Pymble PLC

**PLC Grey House Precinct**

**Accessibility Review Report**

19 July 2021

GENERAL ARRANGEMENT  
PLAN - LEVEL 00

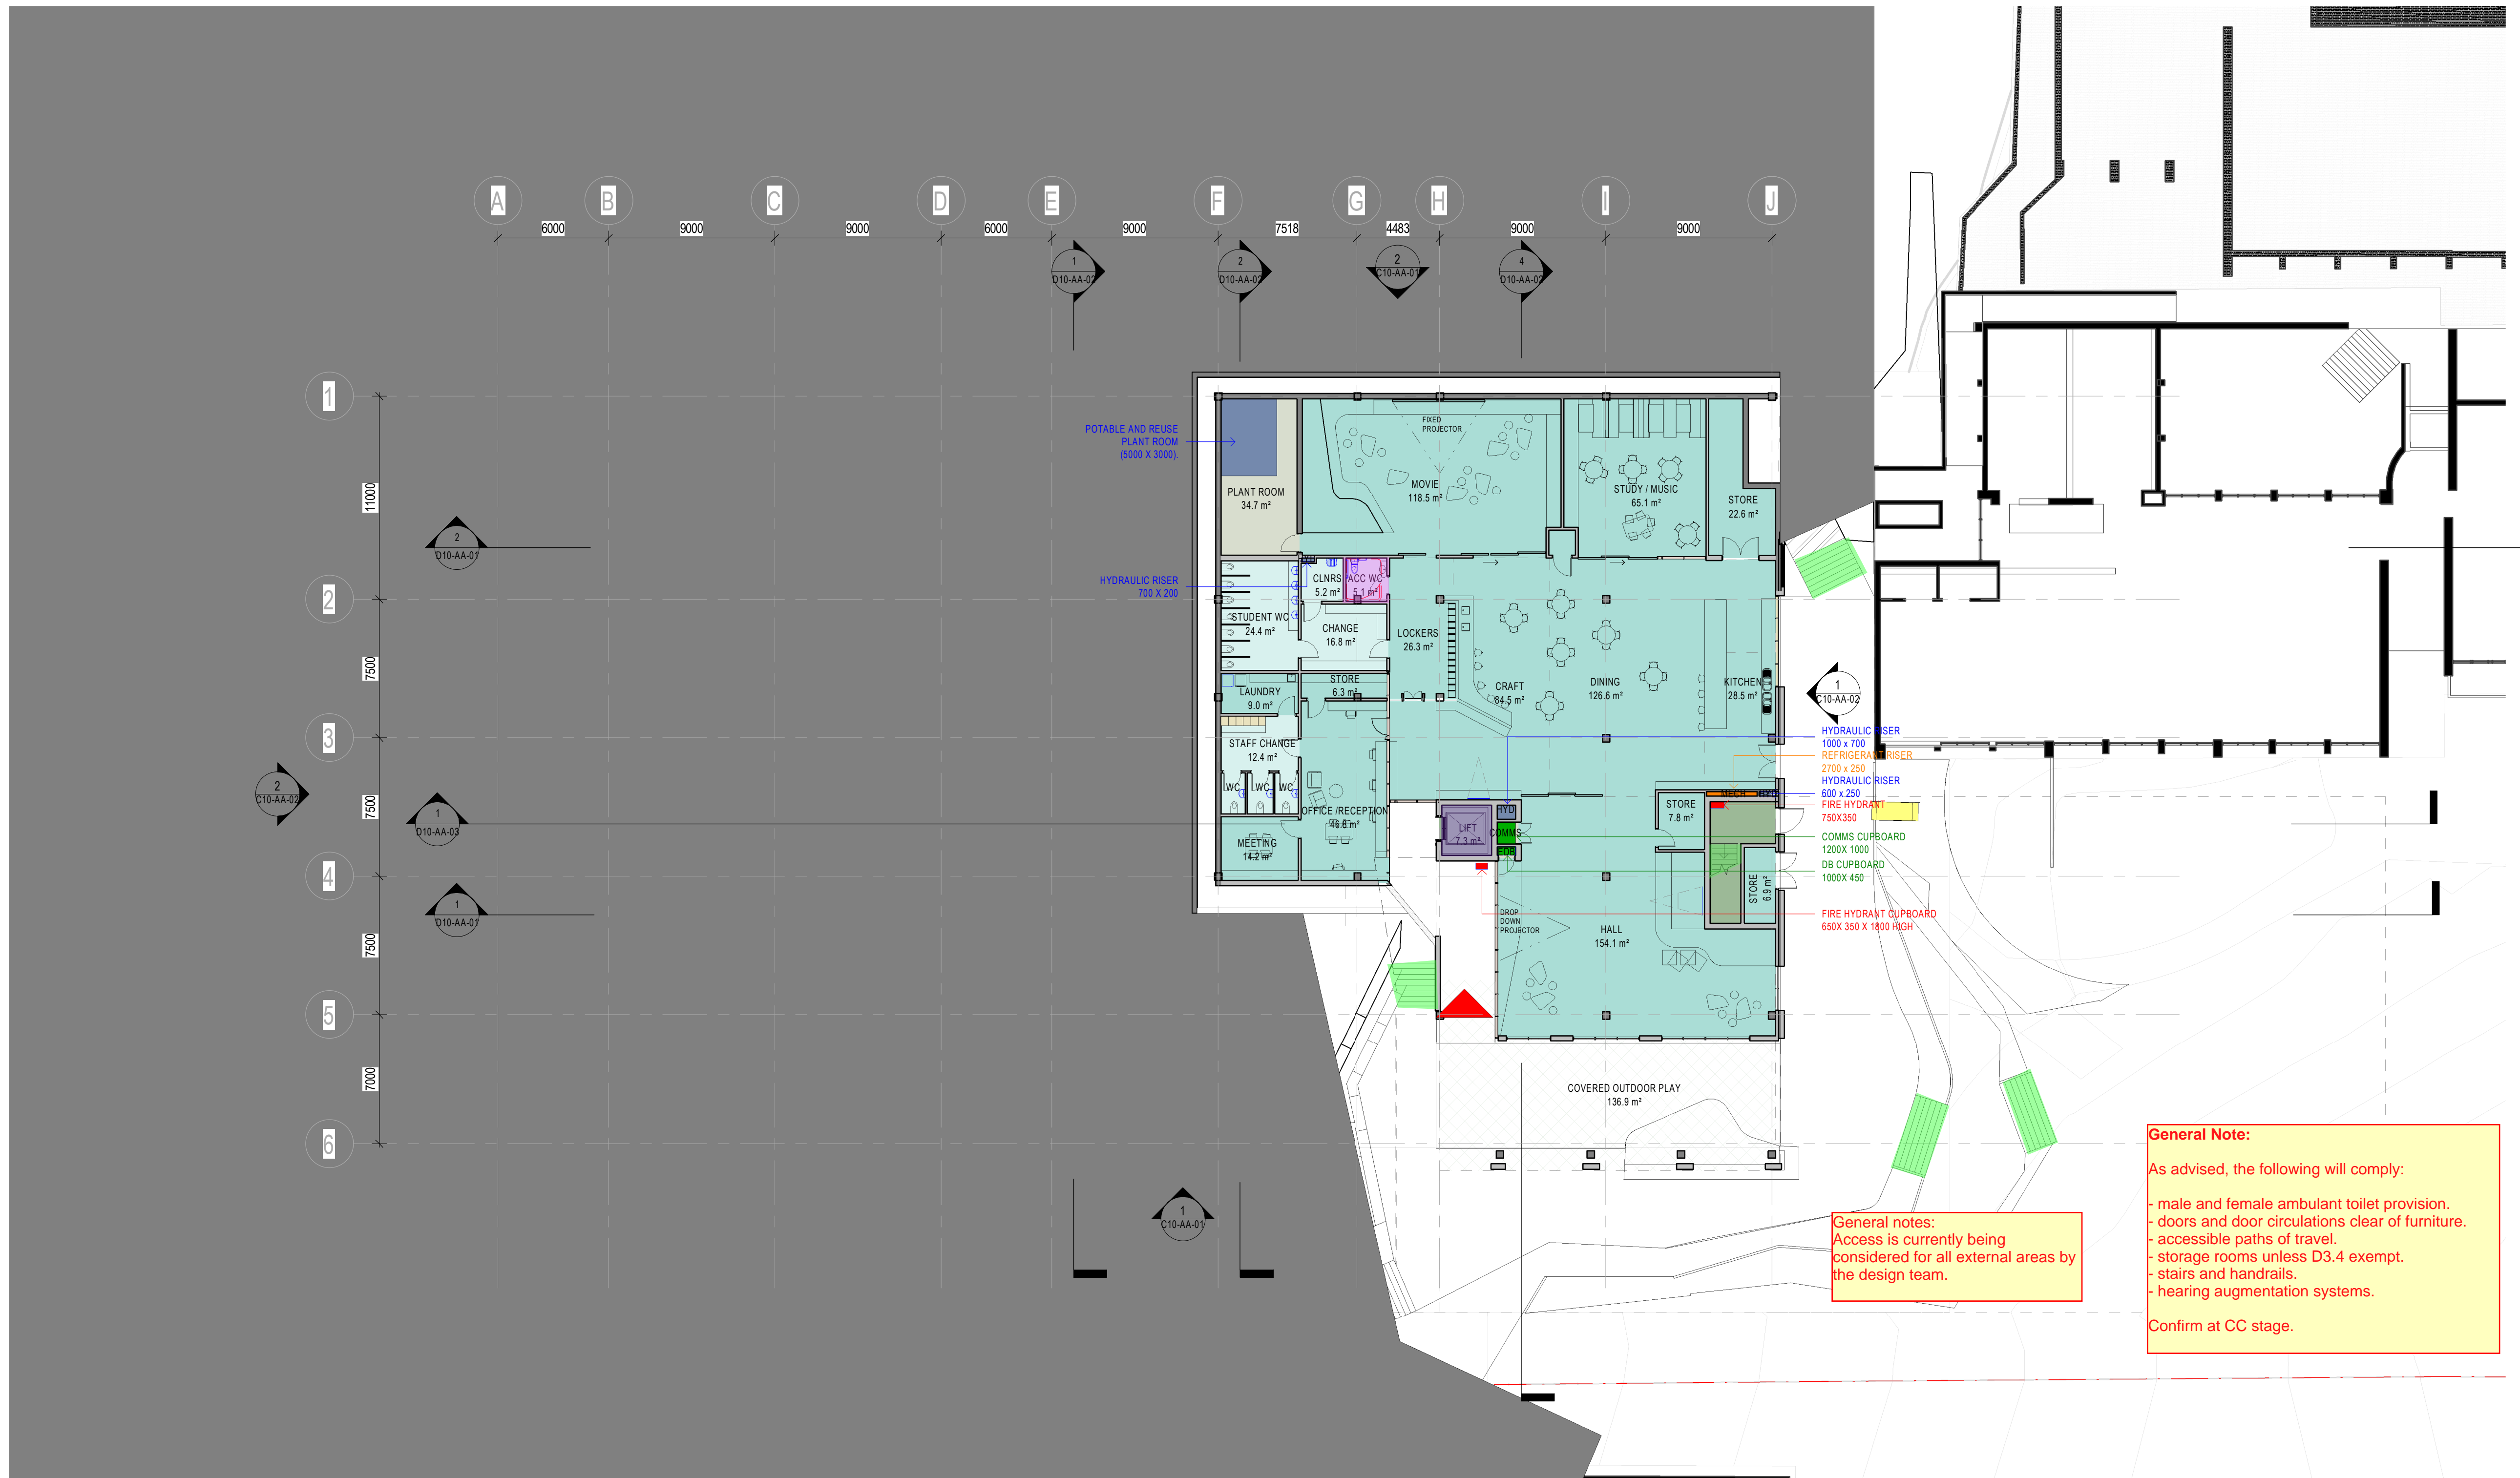
MGAC Review  
19/07/2021  
By: Lee-May Whong

GENERAL ARRANGEMENT  
PLAN - LEVEL 03

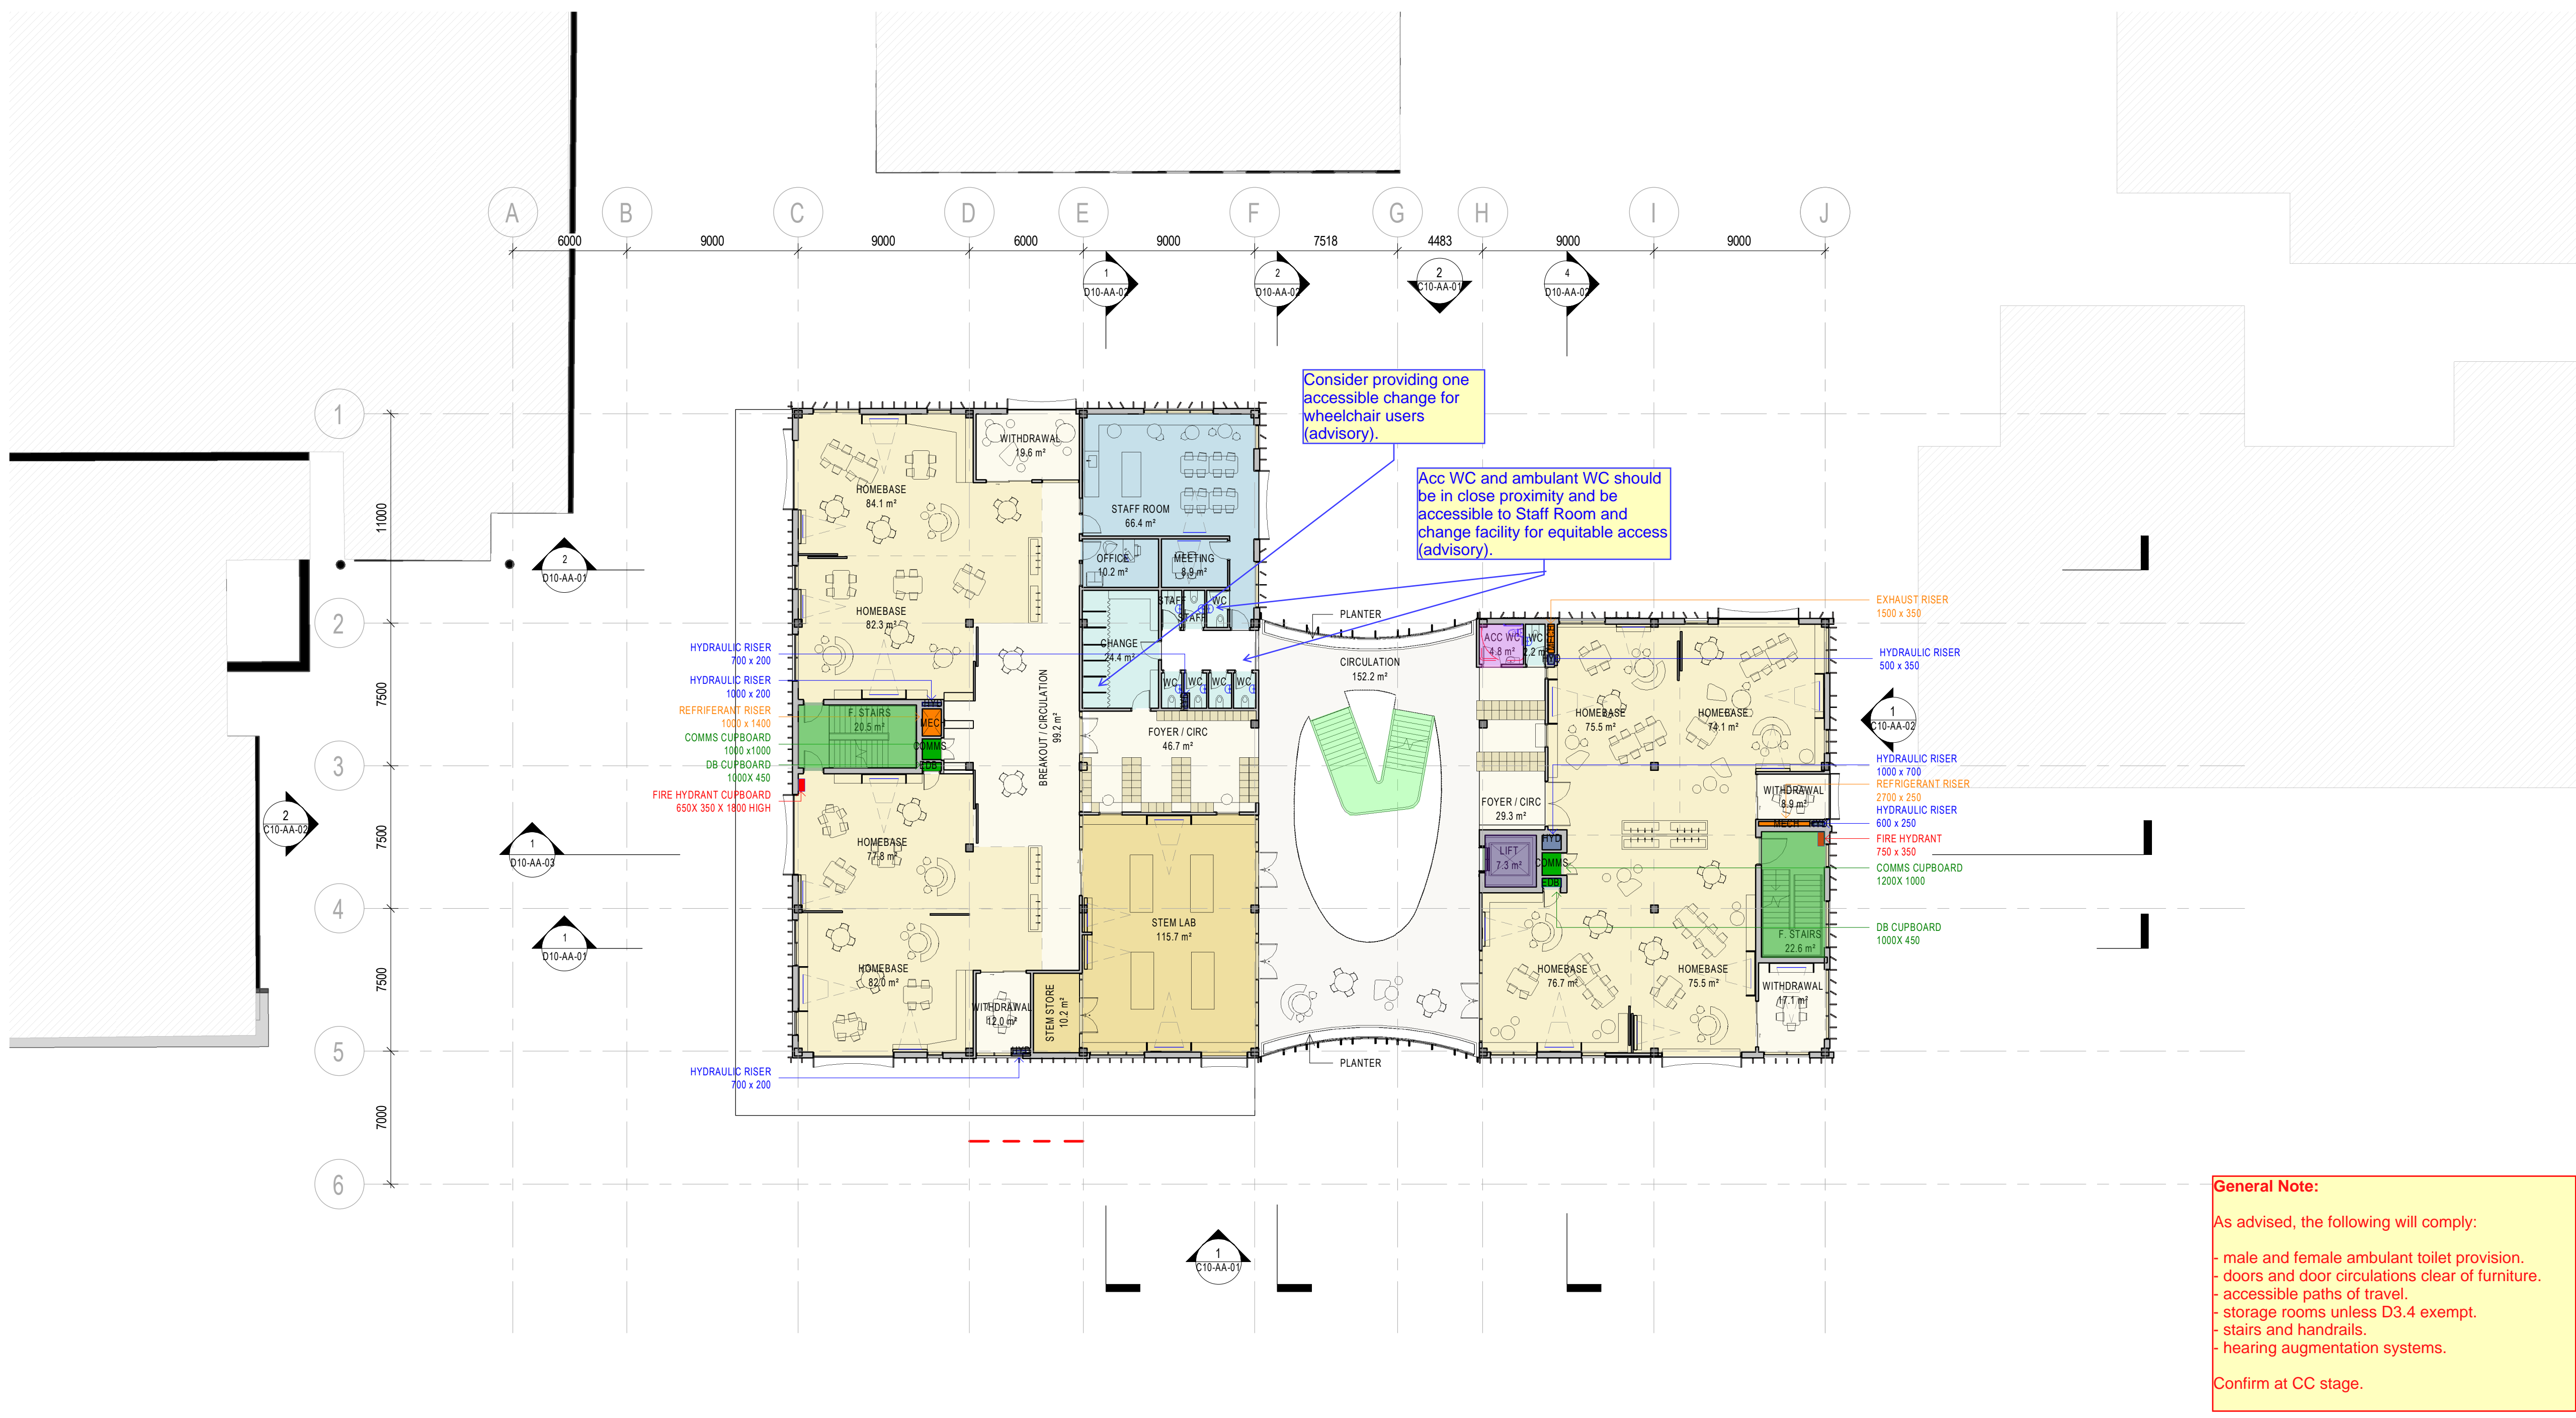
MGAC Review  
19/07/2021  
By: Lee-May Whong

ROOF PLAN

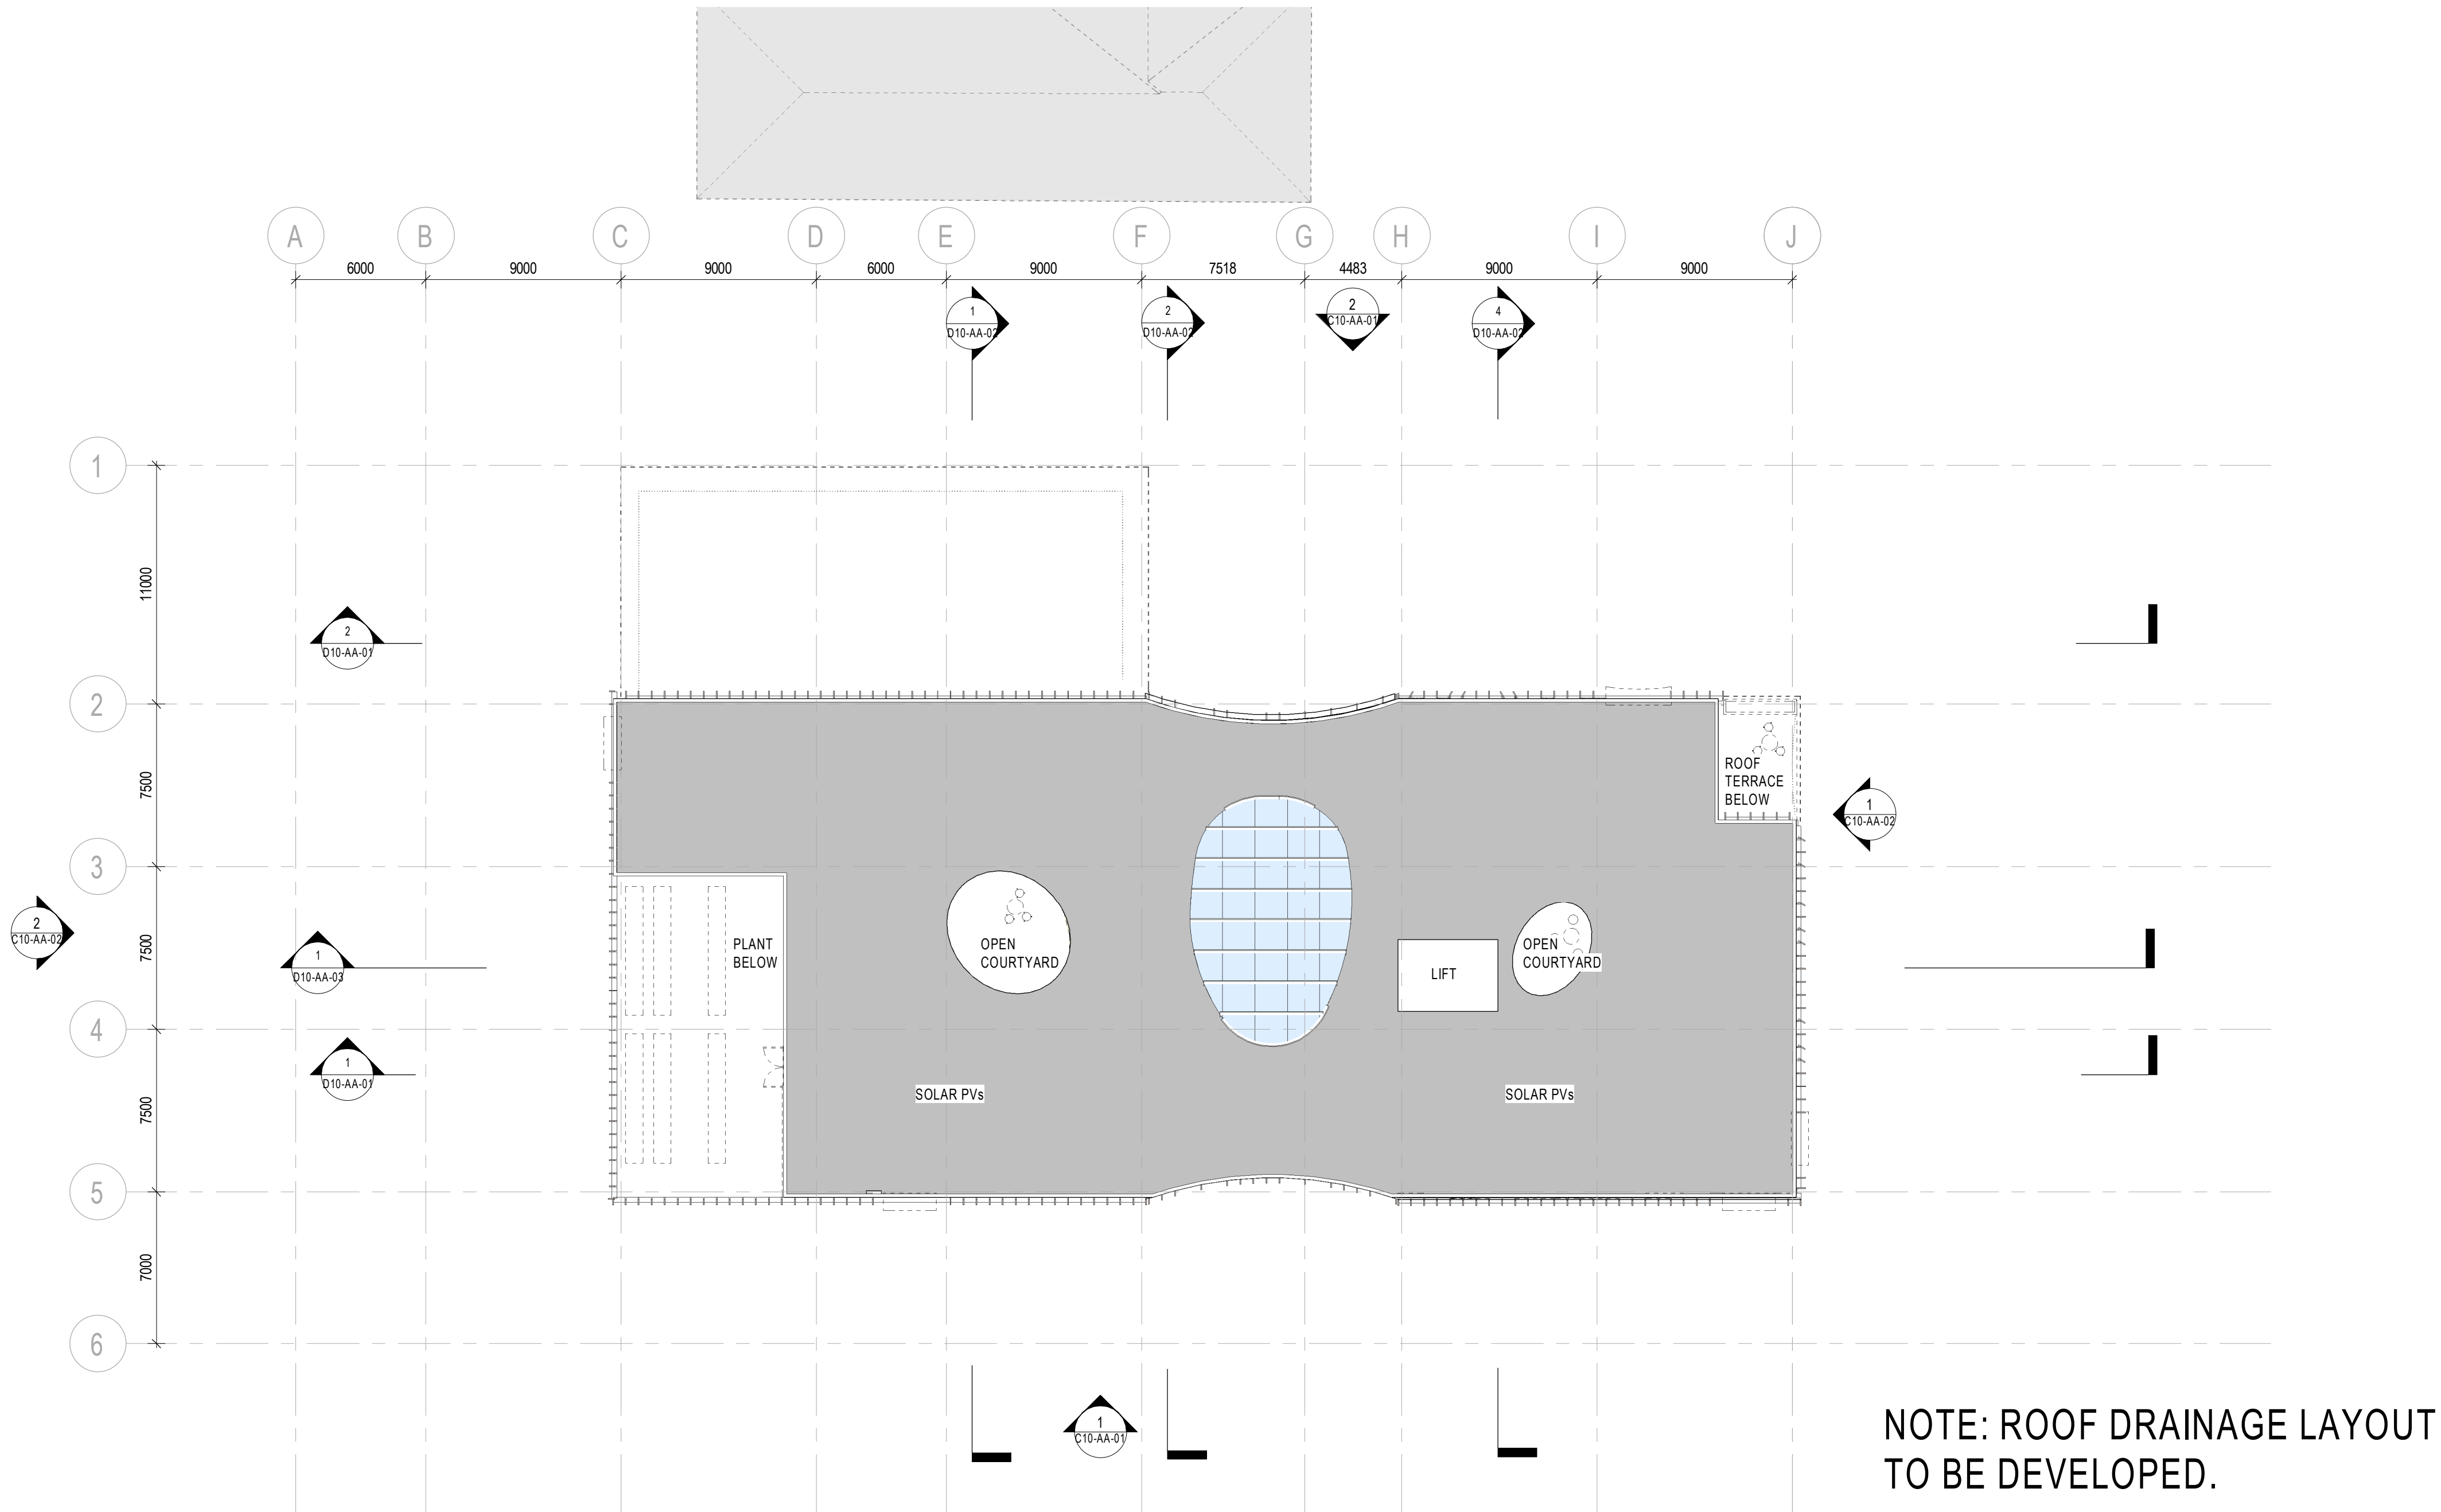
MGAC Review  
19/07/2021  
By: Lee-May Whong
